Wichita-Sedgwick County Metropolitan Area Planning Department

*****SUPERCEDES ZONING ADJUSTMENT DATED JUNE 18, 2004*****

June 28, 2004

Re: **BZA2004-00046: Zoning Adjustment to reduce the front setback from 25 feet to 21 feet and to reduce the side setback on the north from 6 feet to 4.8 feet.**

BZA2004-00096
SITE PLAN
APPROVED 6-28-04 BY SK
1602.6'
132'
15'
135'
N
5
Pipe
4'
12'
13.6'
24'
CARPORT
8.8'
30'
51'
Porch
12 ft
10 ft
25'
Driveway
114'
100'
15 ft
Property Line
268-4390

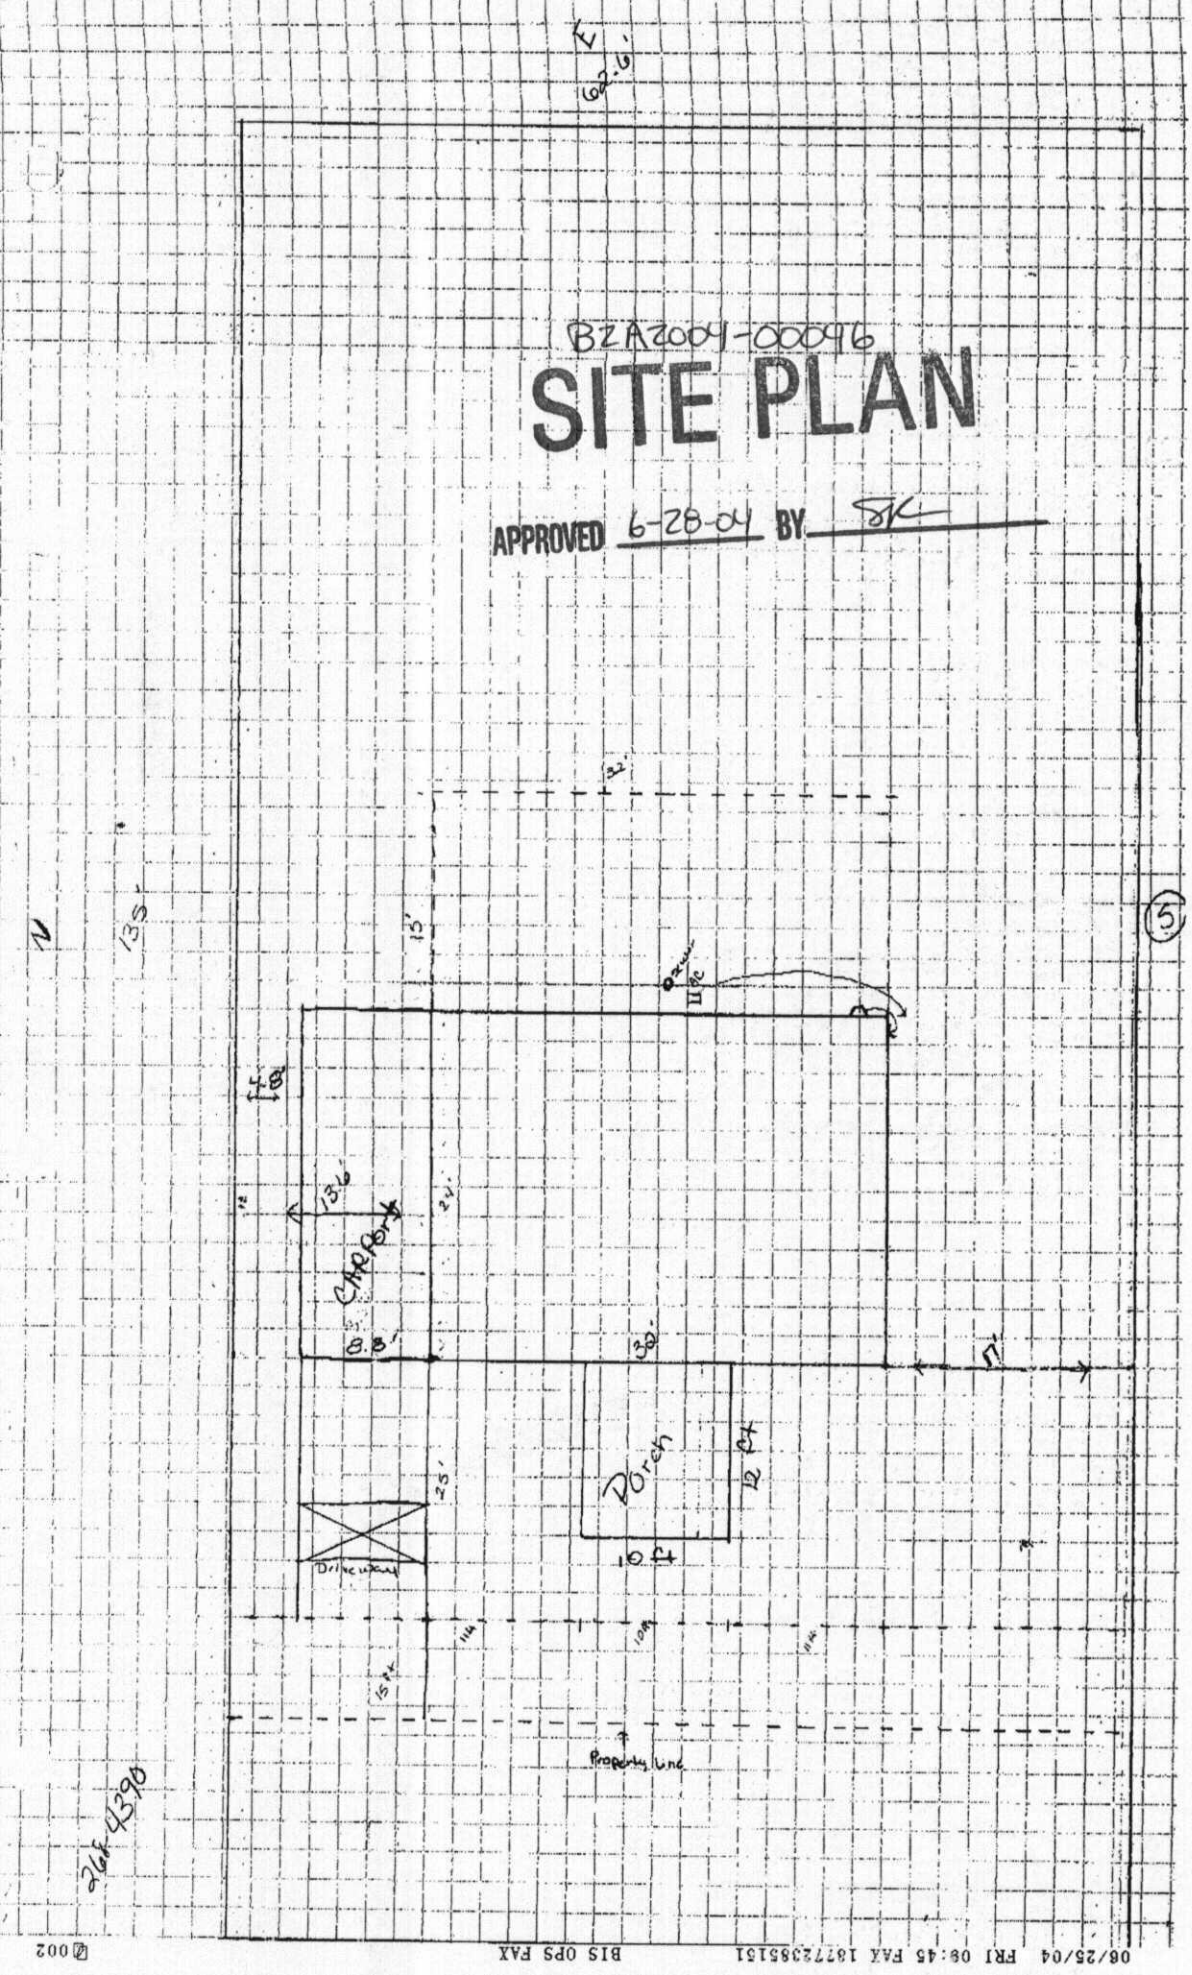
Our signatures below indicate that a Zoning Adjustment to reduce the front setback from 25-feet to 21-feet and the side setback on the north from 6 feet to 4.8 feet is hereby granted for the aforementioned property, subject to the following conditions:

1) The site shall be developed in general conformance with the approved site plan.

2) The setback reduction shall apply only to the "Porch" and "Carport" illustrated on the approved site plan. All other structures or additions on the subject property shall conform to the setbacks permitted by the Unified Zoning Code unless a separate Zoning Adjustment or Variance is granted.

3) The porch and carport shall match the character of the house in terms of material and color.

4) The sides of the porch and carport shall not be enclosed.

We have reviewed your request for a Zoning Adjustment to reduce the setbacks on the aforementioned property. From reviewing your application, we understand that you desire to construct an unenclosed porch that encroaches 12 feet into the 25-foot front setback required by the "SF-5" Single Family zoning district. Since Section III-E.2.e.(1)(i) the Unified Zoning Code allows an unenclosed porch to encroach into the front setback by only 8 feet, you are requesting to reduce the front setback from 25 feet to 21 feet so that the encroachment of the proposed unenclosed porch into the front setback will be only 8 feet. We further understand that you propose to construct an unenclosed carport that encroaches 1.2 feet into the 6-foot side setback required by the "SF-5" Single Family zoning district.
